**RFP Title: GENERAL CONTRACTOR SERVICES FOR JOSLIN RECREATION CENTER CPF
IMPROVEMENTS**

Addendum #: 1

*****ADDENDUM ONE*****

**City of Providence
Department of Public Property
Joslin Recreation Center – CPF Renovation
17 Hyatt Street
Providence, RI 02903**

2 FIRST FLOOR CEILING DEMOLITION PLAN
A1.03 3/32" = 1'-0"

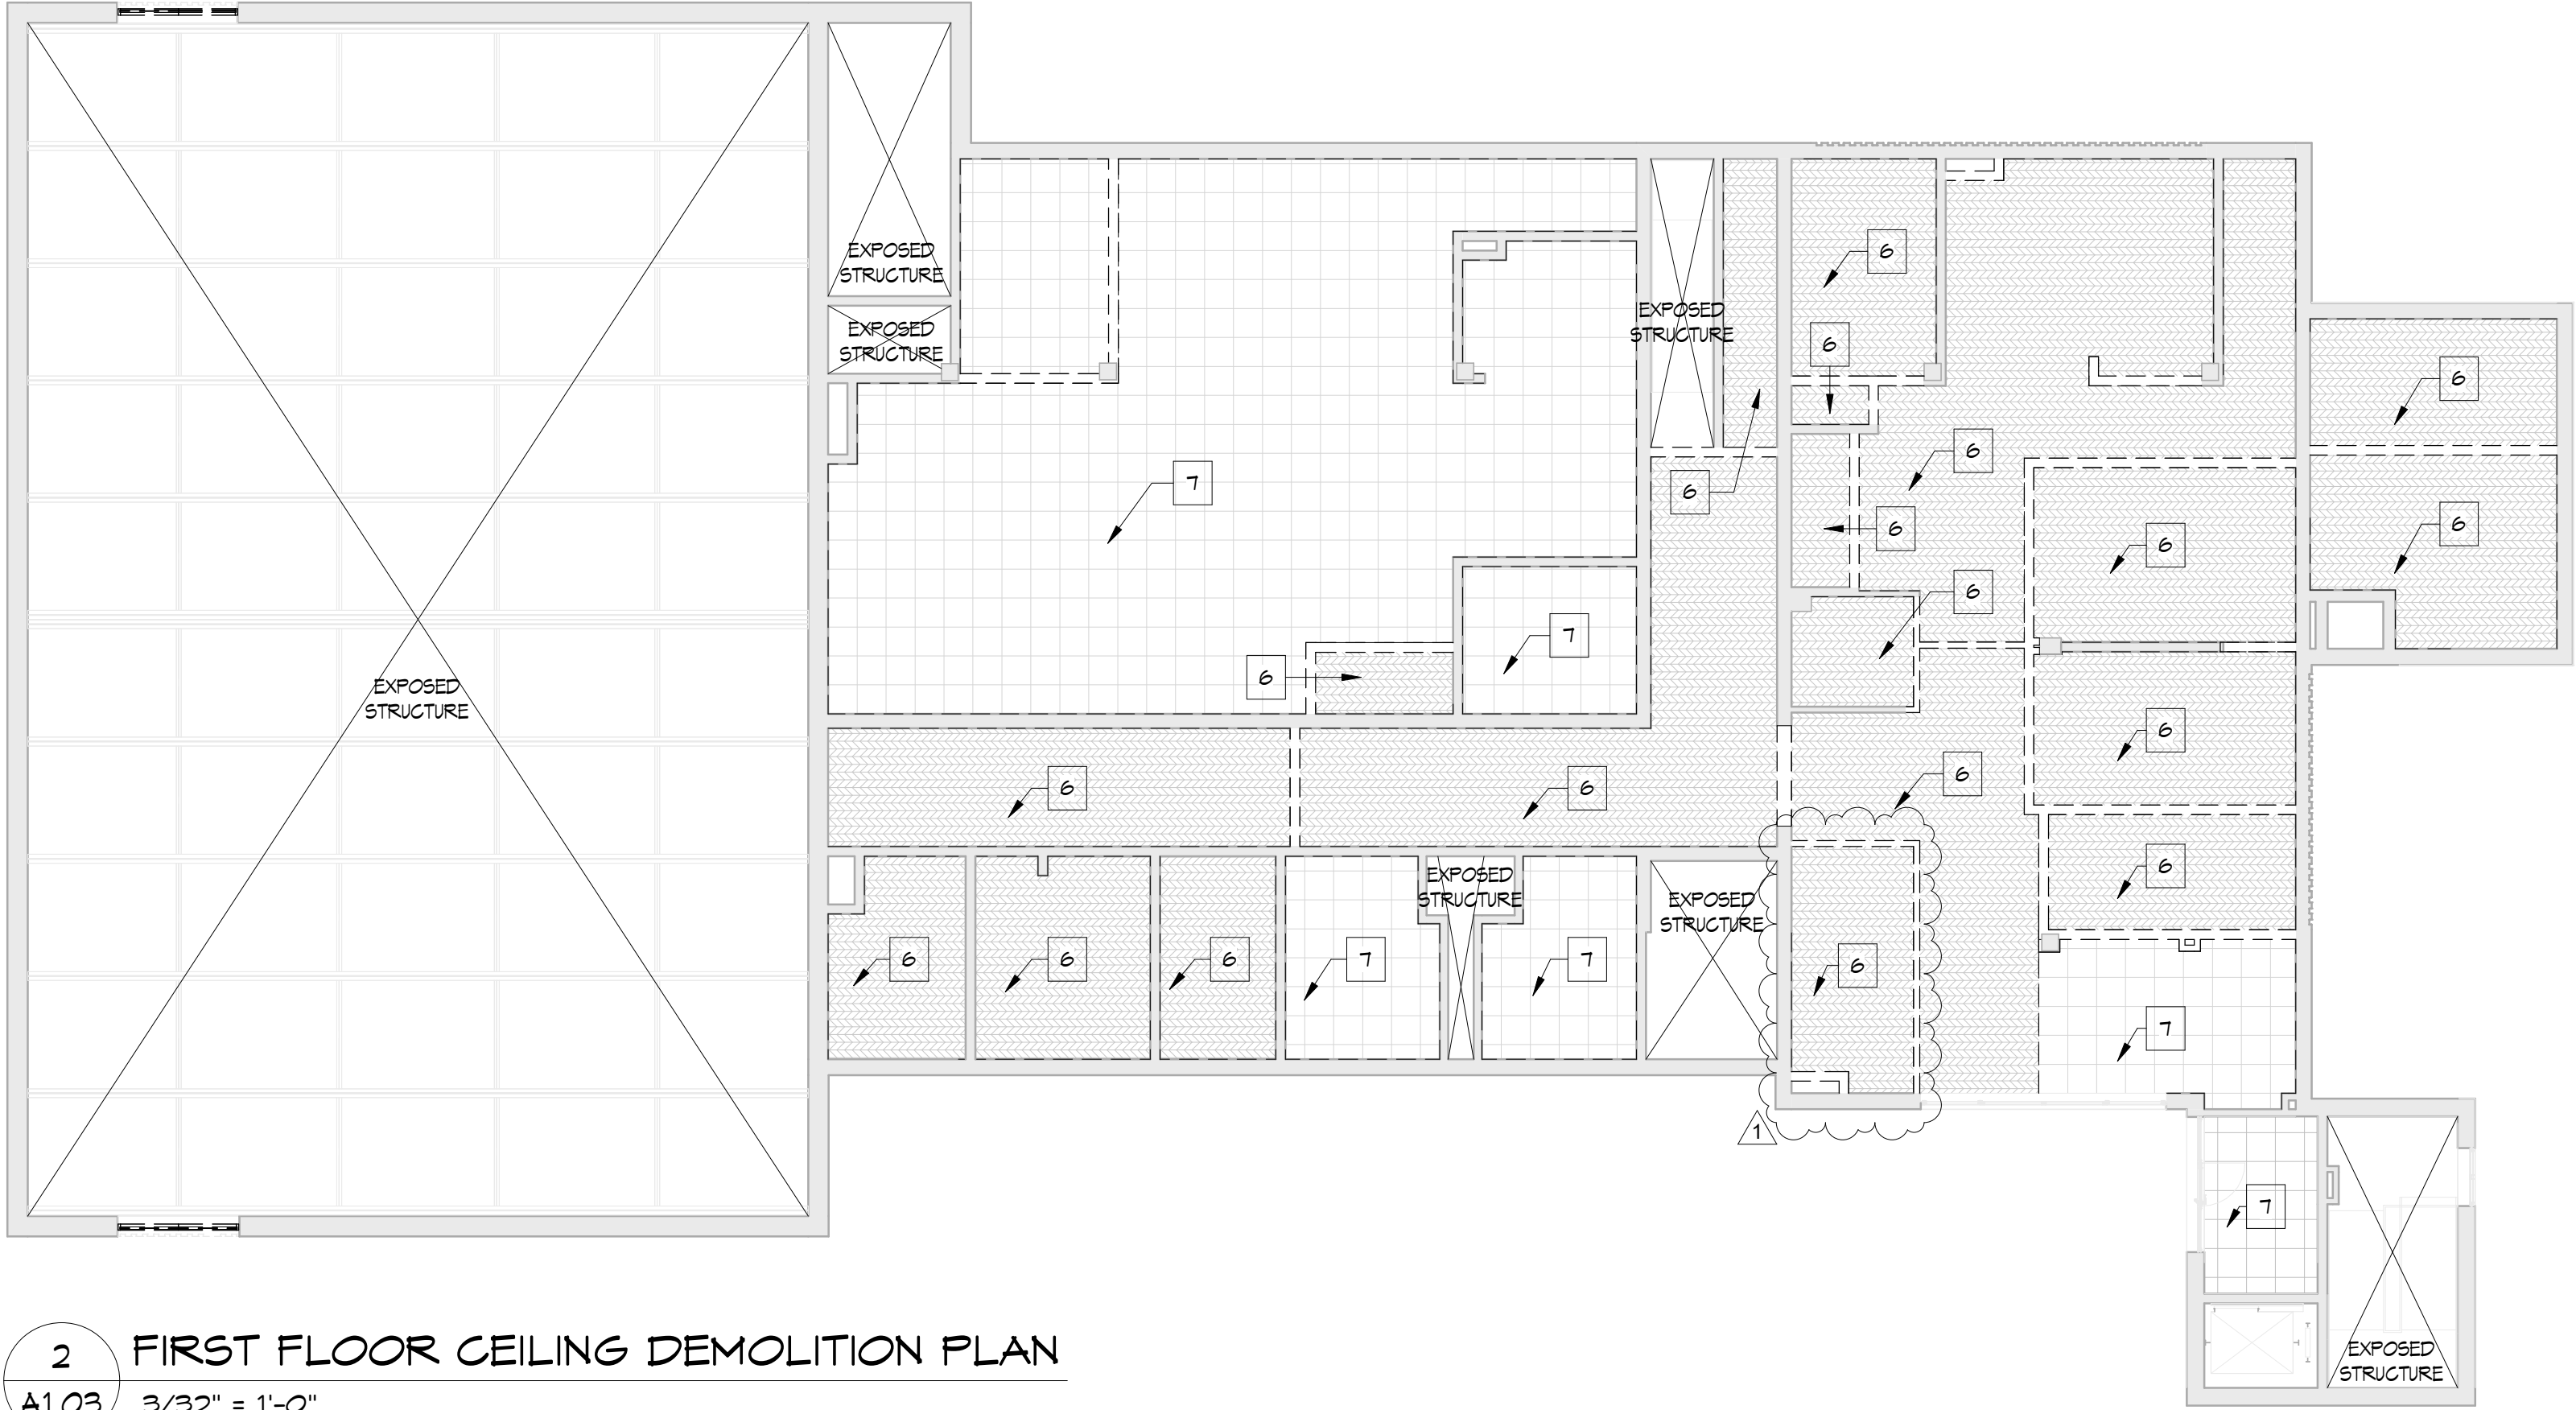
- Please confirm if demolition work per notes 6 & 7 AD1.00 are to be done? It is listed in notes but not shown on floor plan

Answer – Refer to sheet A1.03 for Ceiling Demolition information.

Demolition notes 6 & 7 are being used and are indicated on drawing 2/ A1.03. All existing First Floor Ceiling finishes and/ or Substrates, as occurs, are being removed and replaced with New Ceiling finishes.

2 ENLARGED FLOOR PLAN CYBER LOBBY
A2.00 1/4" = 1'-0"

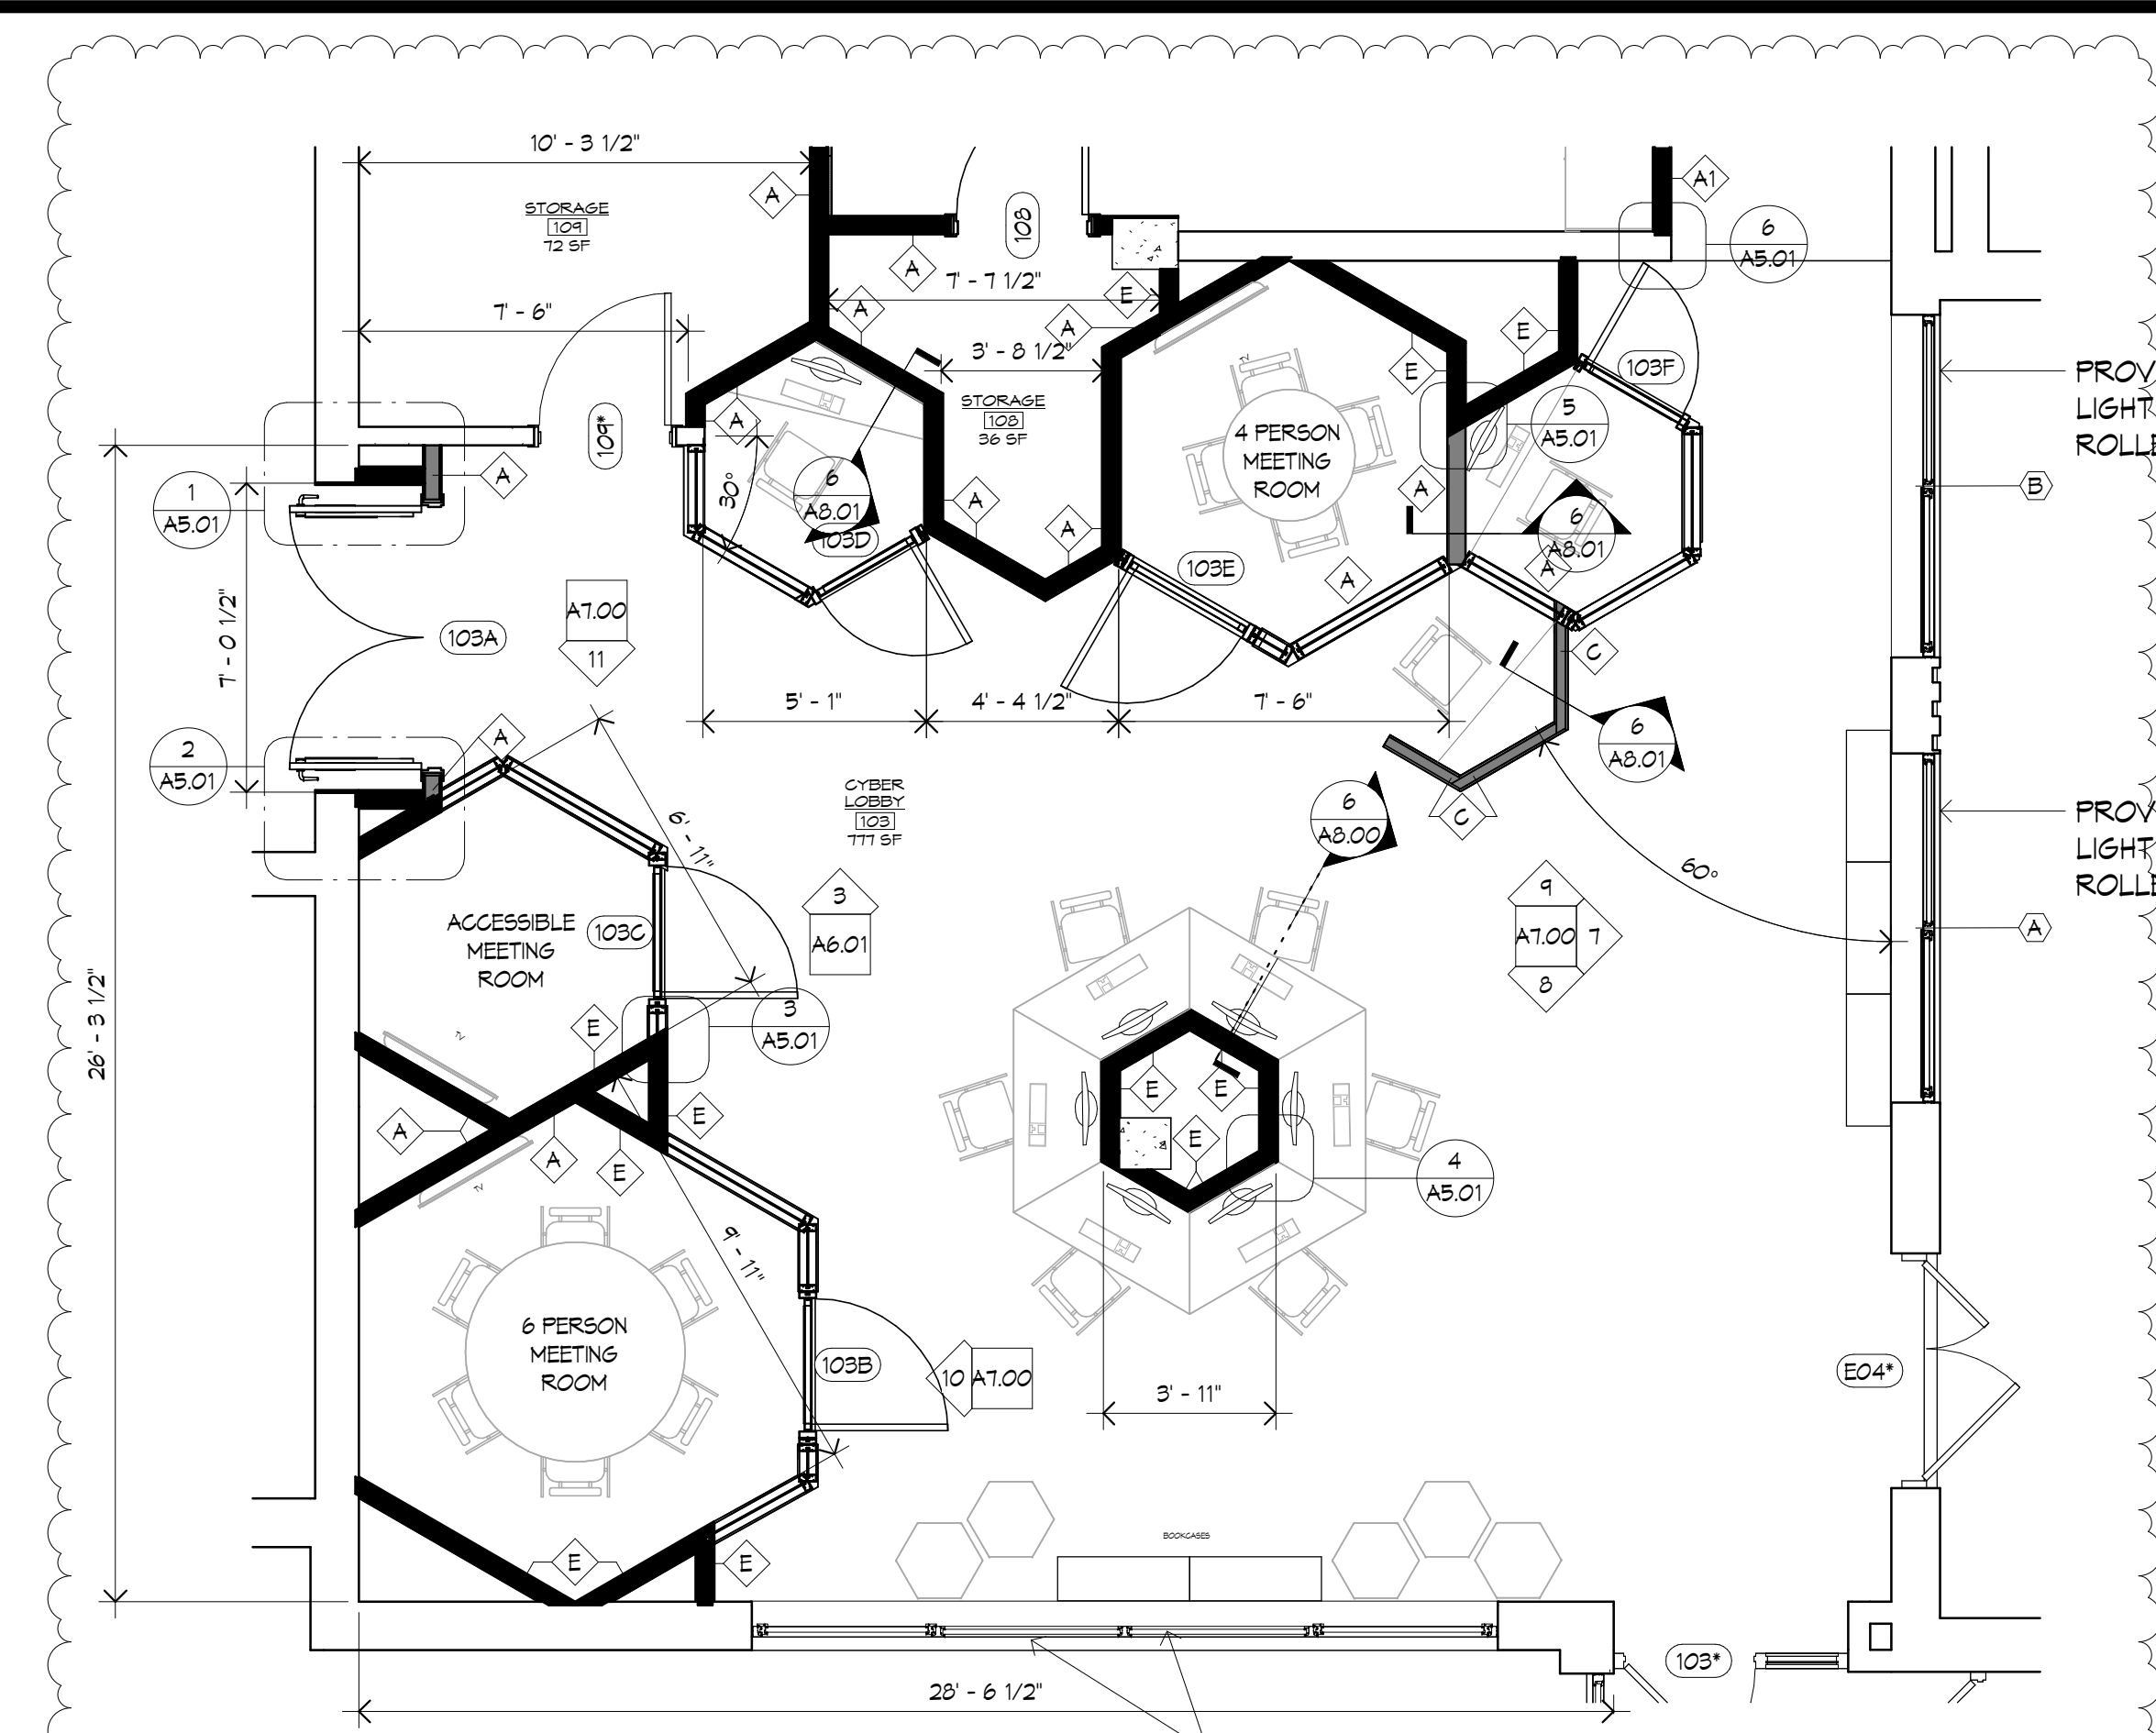
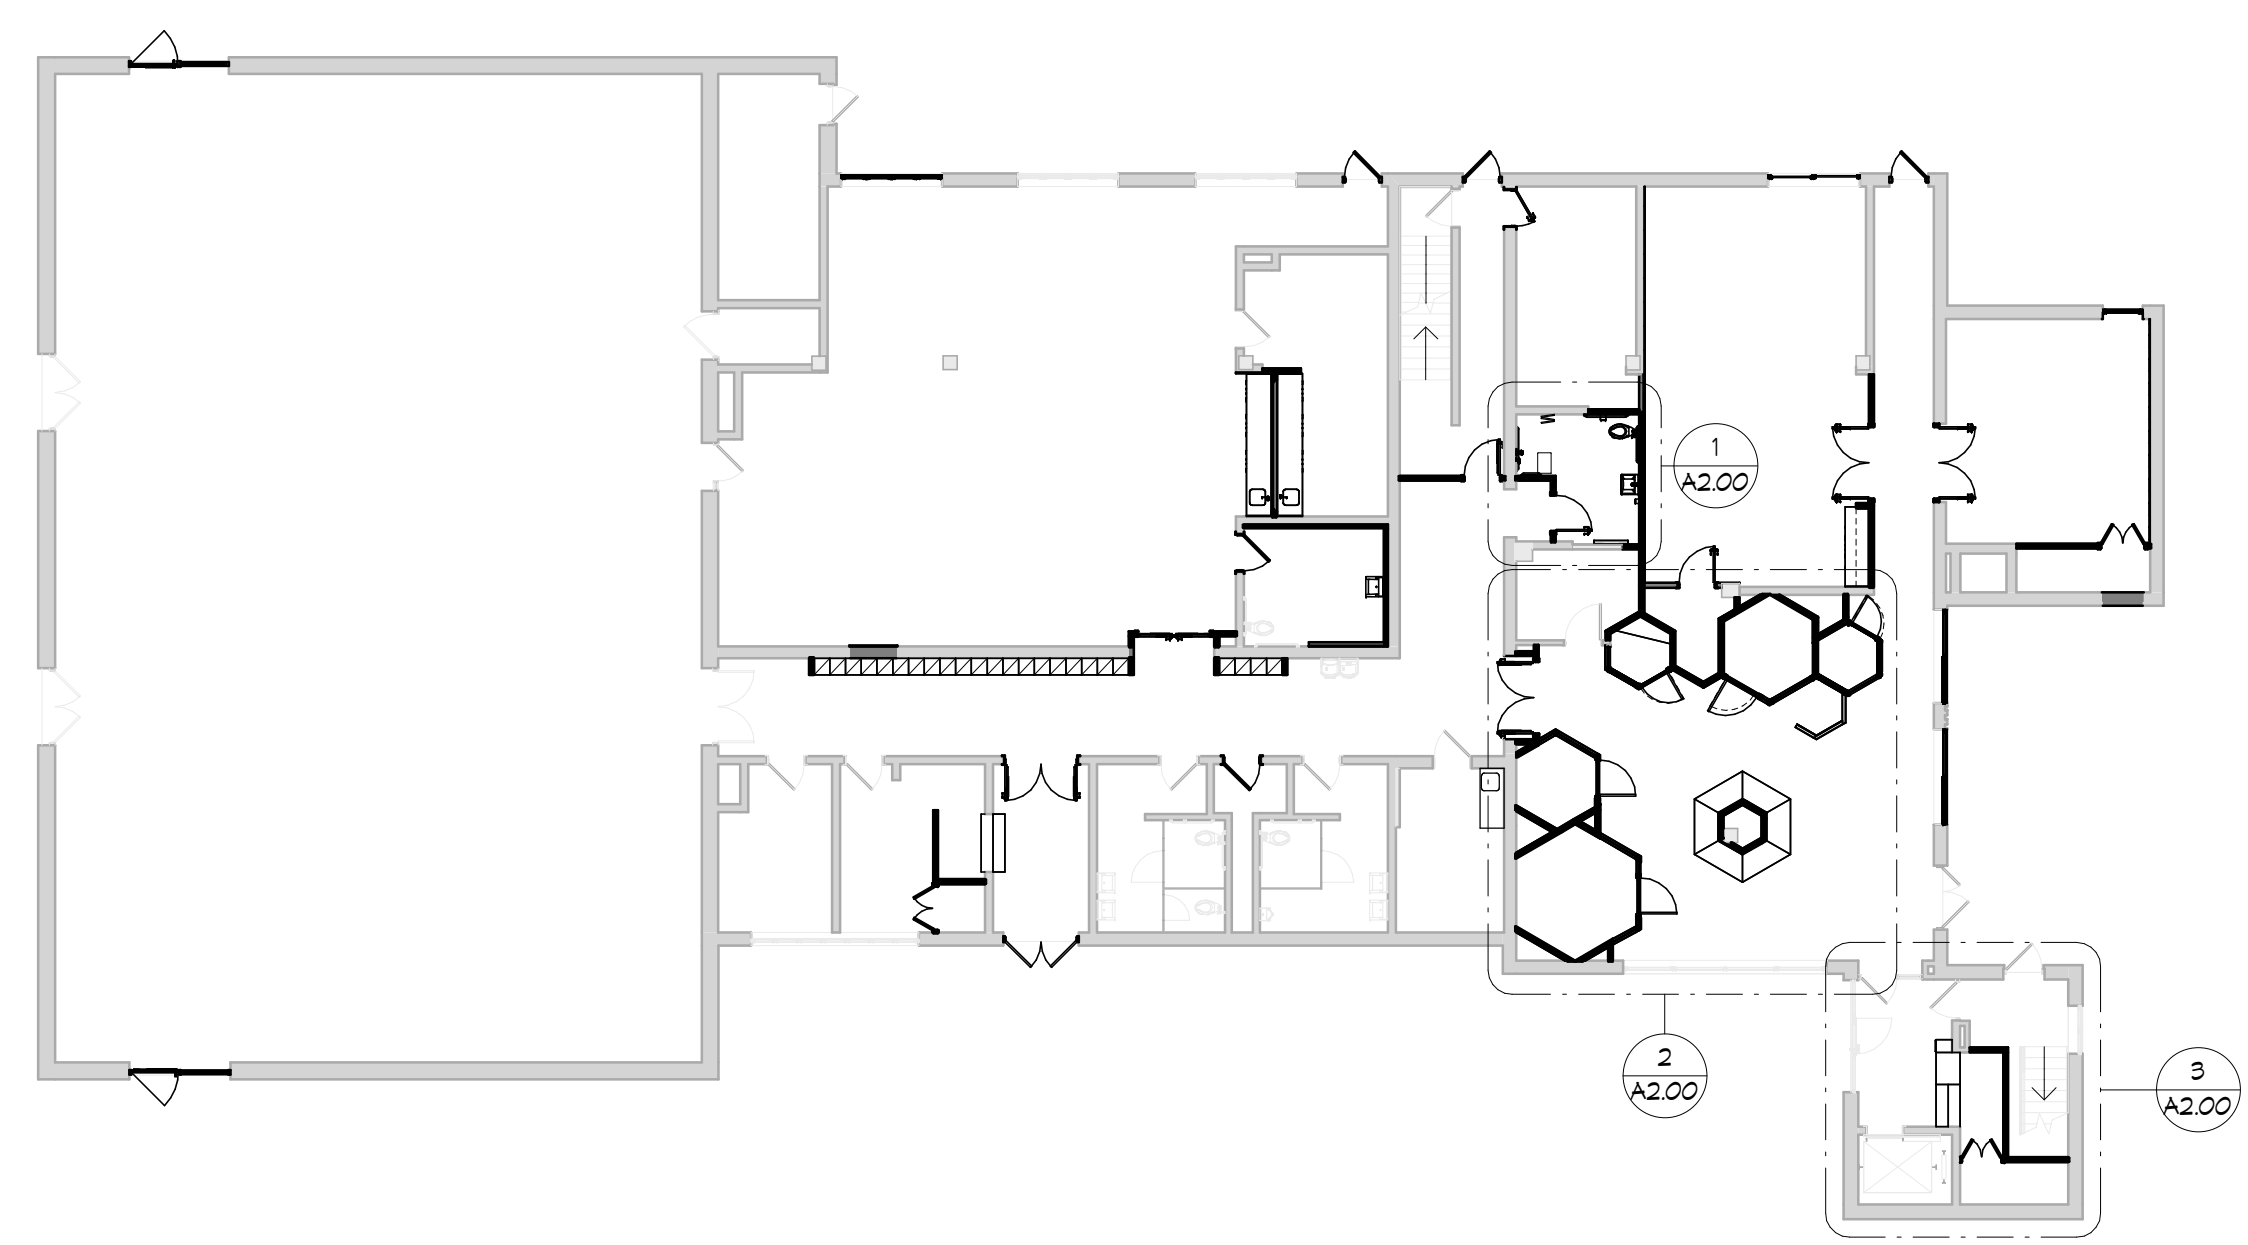
- In rooms 103D and 103f the floor plan shows a counter line with a computer on it, but these are not called off or elevated. Do we need to carry anything for these?

Answer – Yes, a countertop with gamba support brackets is to be provided and installed at these locations. Refer to Revised drawing A2.00 included in this Addendum for information.
